MISSISSIPPI POWER & LIGHT COMPANY

SUBJECT: Grand Gulf Nuclear Station
Units 1 and 2
Docket Nos. 50-416 and 50-417
License No. NPF-13
File 0260/0272/L-860.0
Humphrey Containment Concerns
AECM-83/0146

Reference letter 3 contained a commitment from Mississippi Power & Light Company (MP&L) to respond to a number of questions raised by your staff's consultants regarding MP&L's work addressing the containment concerns raised by Mr. John Humphrey. Attachment one to this letter contains responses to five of the six items listed in reference letter 2.

SCHEMATIC OF RHR PRESSURE RELIEF VALVE DISCHARGE LINE

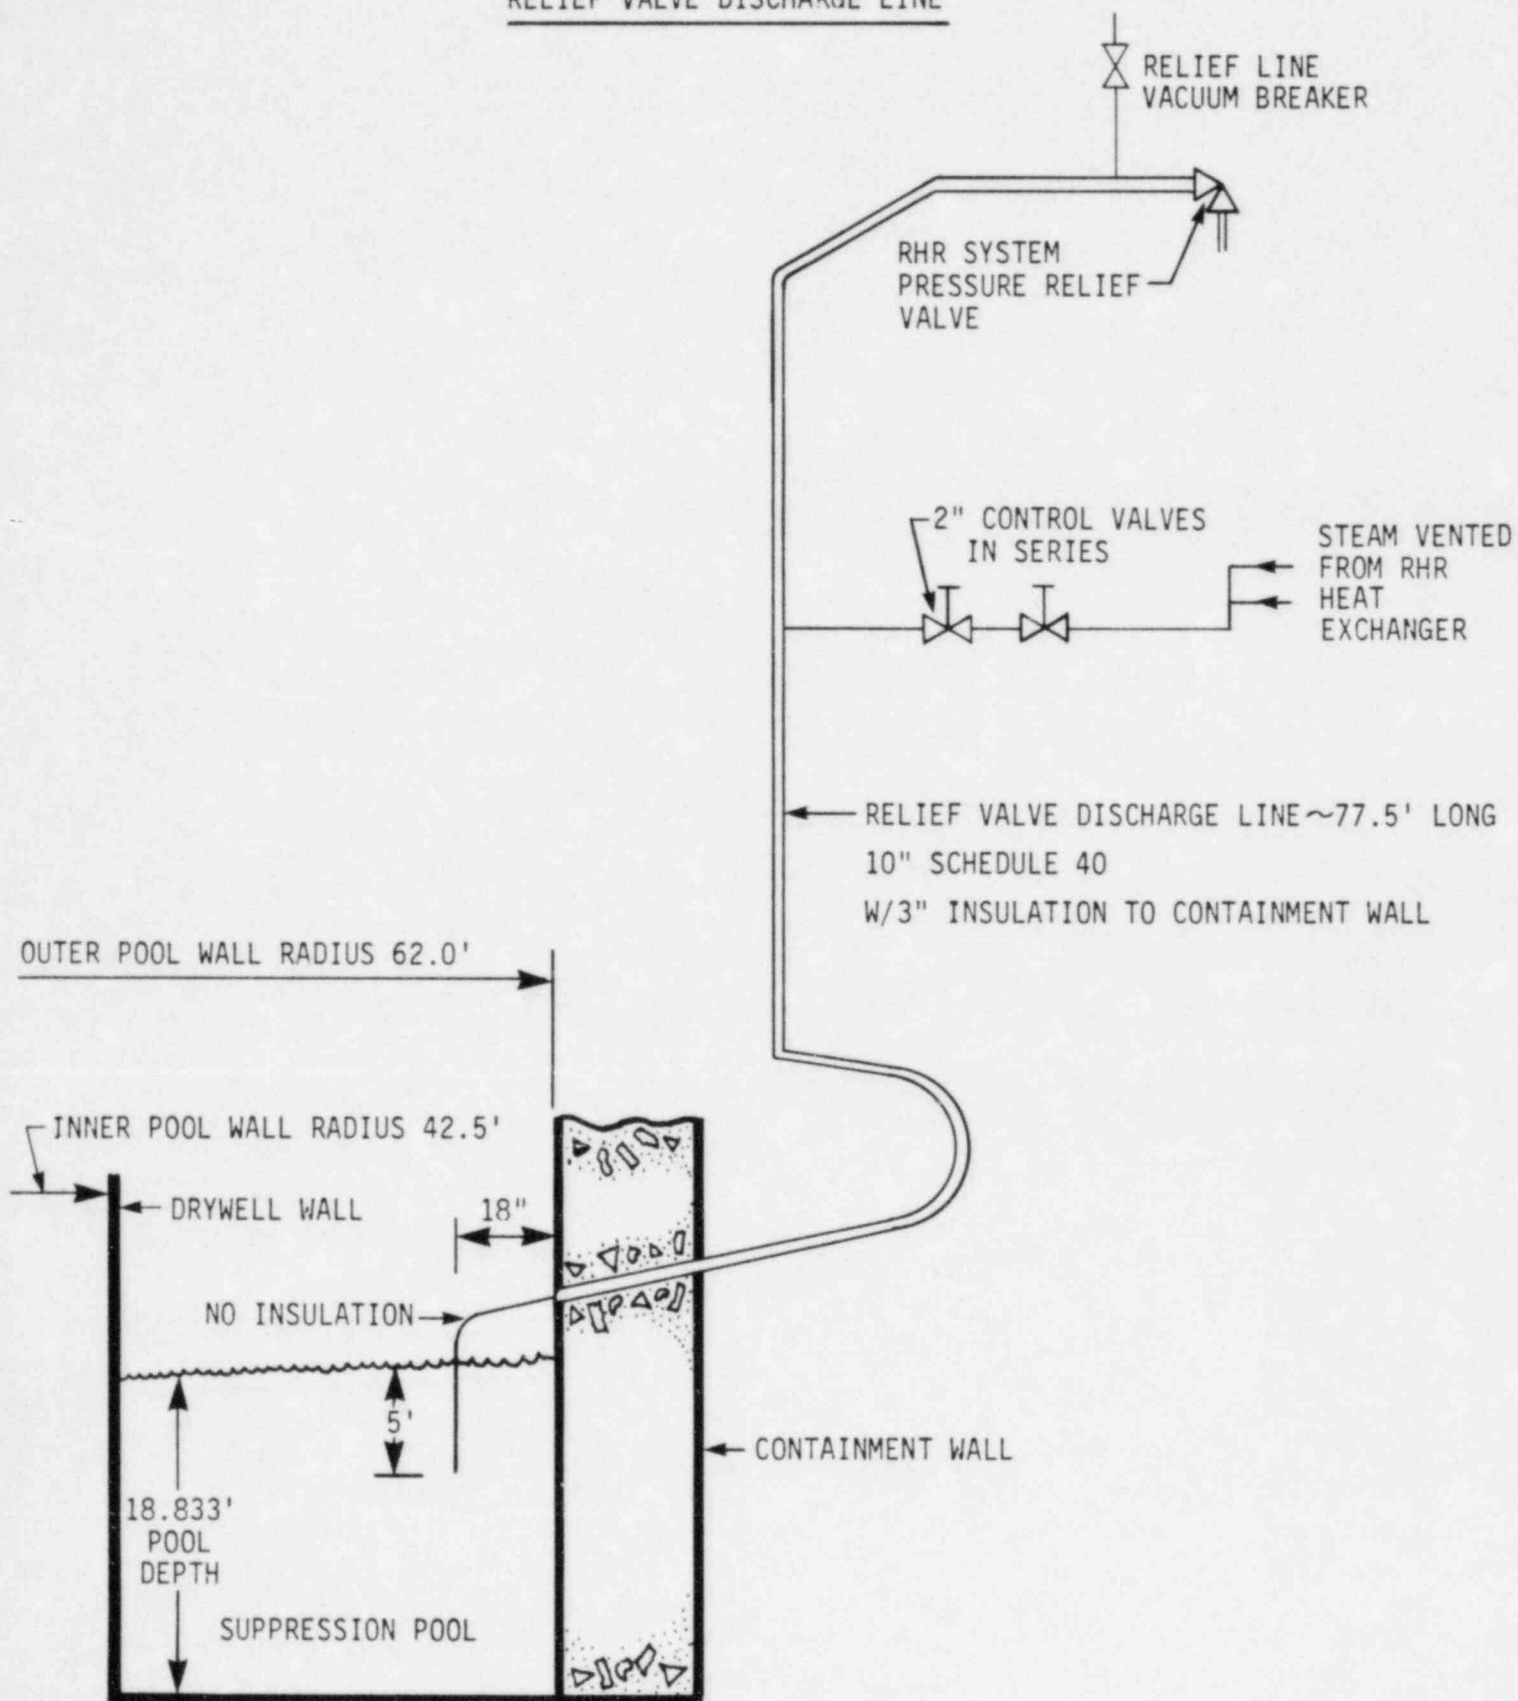
I.6.1 Quantify the maximum lateral loads which could be applied to the RHR heat exchanger relief valve discharge line as a result of chugging in the discharge line.

During operation of the RHR system in the steam condensing mode, steam vented from the RHR heat exchanger is bled into the discharge line, downstream of the pressure relief valve in the RHR system. A schematic of the relief valve discharge line and the non-condensable

bleed line piping is shown in Figure 1. Steam is extracted from the RHR heat exchanger at two locations, passes through two 2" valves in series which control the steam flow, and enters the relief valve discharge line in its vertical run, outside the containment. The total extraction flow has been estimated to be just under 1 lbm/sec. This flow through the 10" relief valve discharge line results in a steam mass flux of 1.8 lbm/sec ft² into the suppression pool. This is within the range of steam mass fluxes over which chugging would be expected to occur in the pool. Chugging from the relief valve discharge line will result in pool boundary loads in the suppression pool and lateral loads on the discharge line. The chugging loads which result from the steam discharges through the RHR heat exchanger relief valve discharge line will be similar to the vertical vent Mark II chugging loads. The methods used to evaluate chugging loads for the Mark II containment are described next.

Figure 1 Grand Gulf-Single S/R Valve Normalized Walls - Floor Pressure at 0°

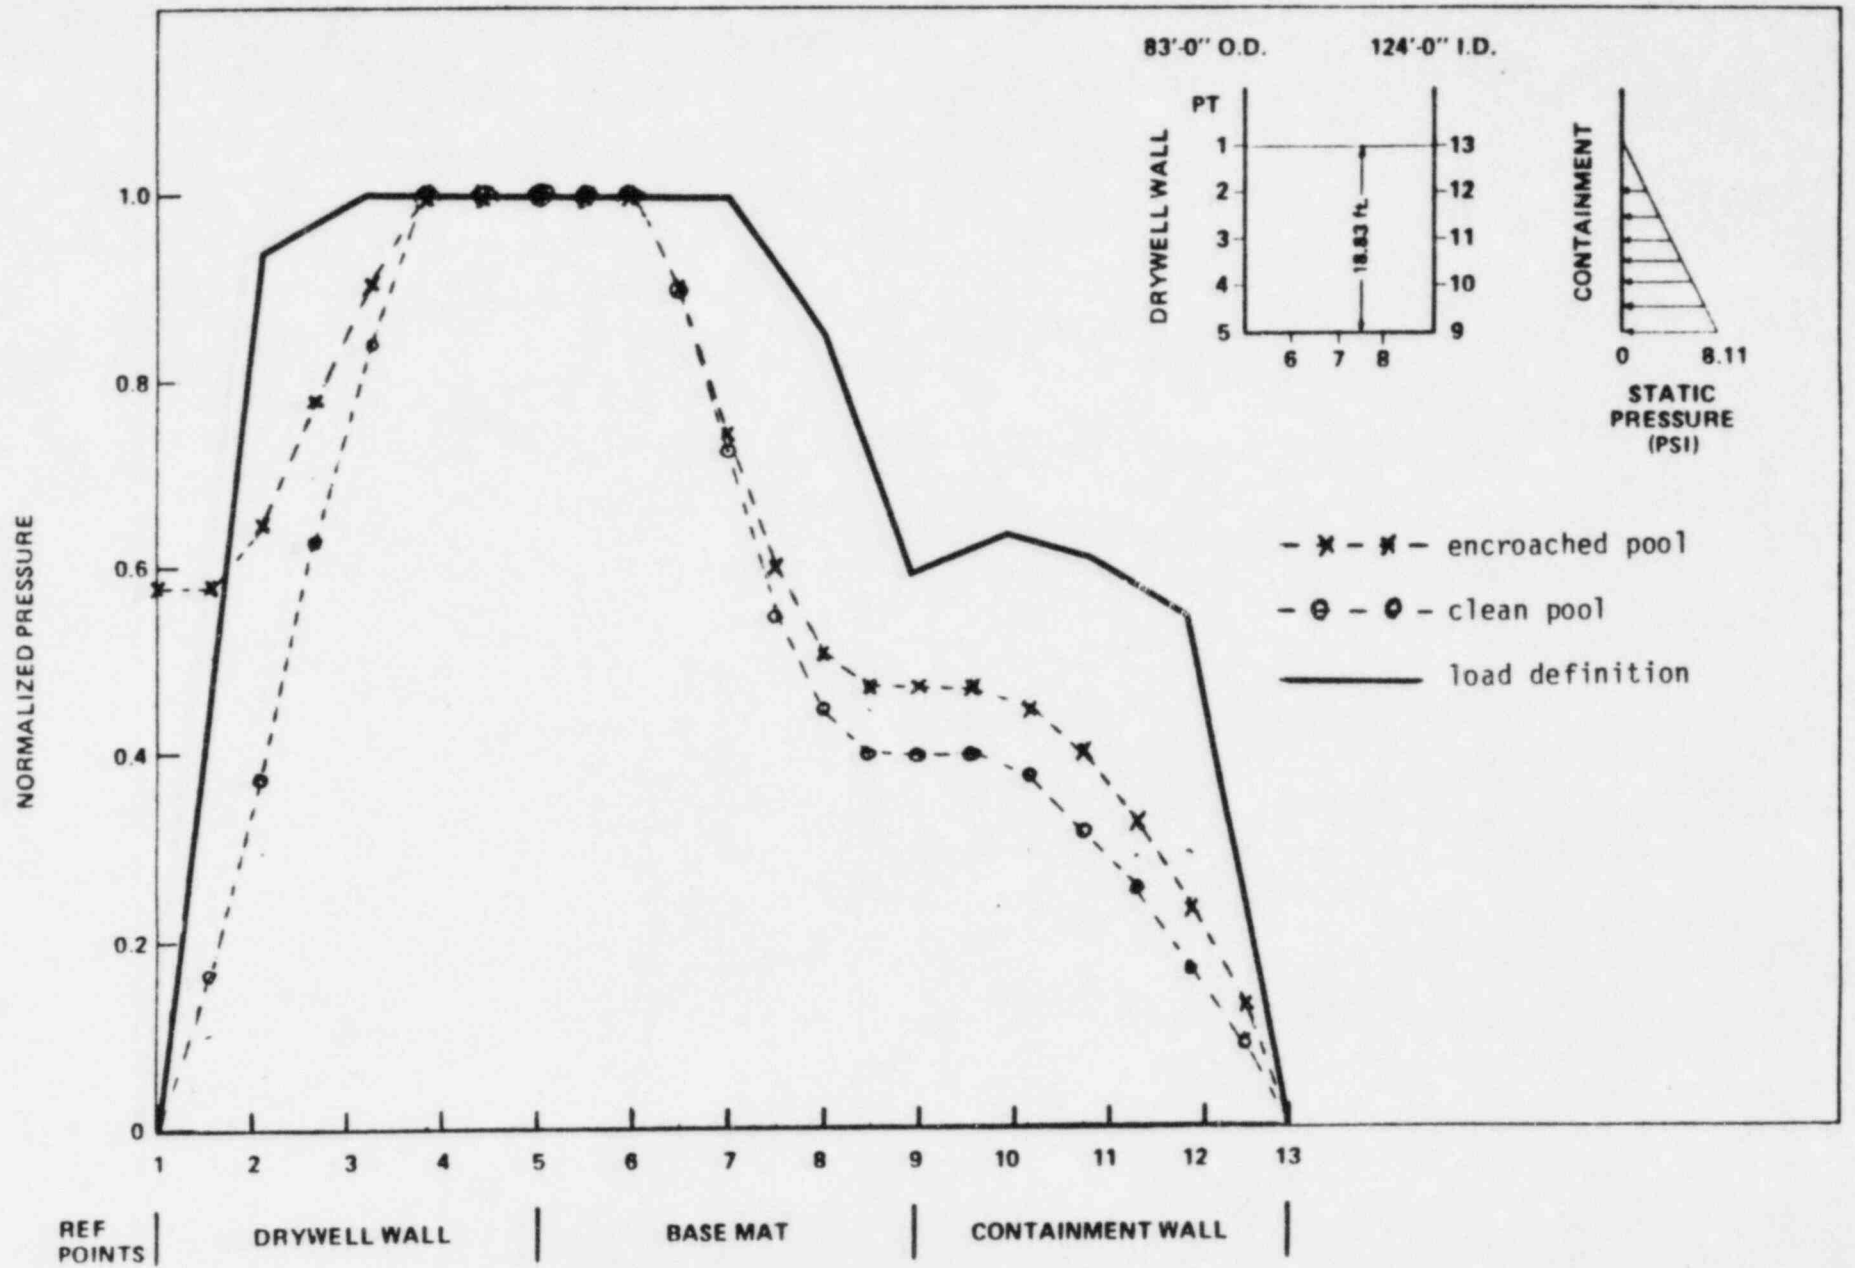
I.B The location of SRV quenchers under the TIP platform may produce changes in the SRV quencher loads.

An acoustic model of the suppression pool was used to evaluate possible increases in the normalized pool boundary loads due to actuation of the SRV located under the encroachment. The input bubble pressure was a five hertz sine wave of unit amplitude. The acoustic model was shown to predict SRV quencher attenuations using Caorso test data. Figure 1 shows a comparison of the attenuation predicted by the acoustic model and the attenuation measured in the Caorso tests. Figure 2 shows that the expected attenuations for the GGNS suppression pool for the clean and encroached pool cases are bounded by the load definition everywhere except high on the drywell wall. This increase over the load definition, however, is bounded by the pool swell load definition.

MP&L concludes that existing load definitions adequately bound all possible increases in SRV loads due to any pool encroachments.
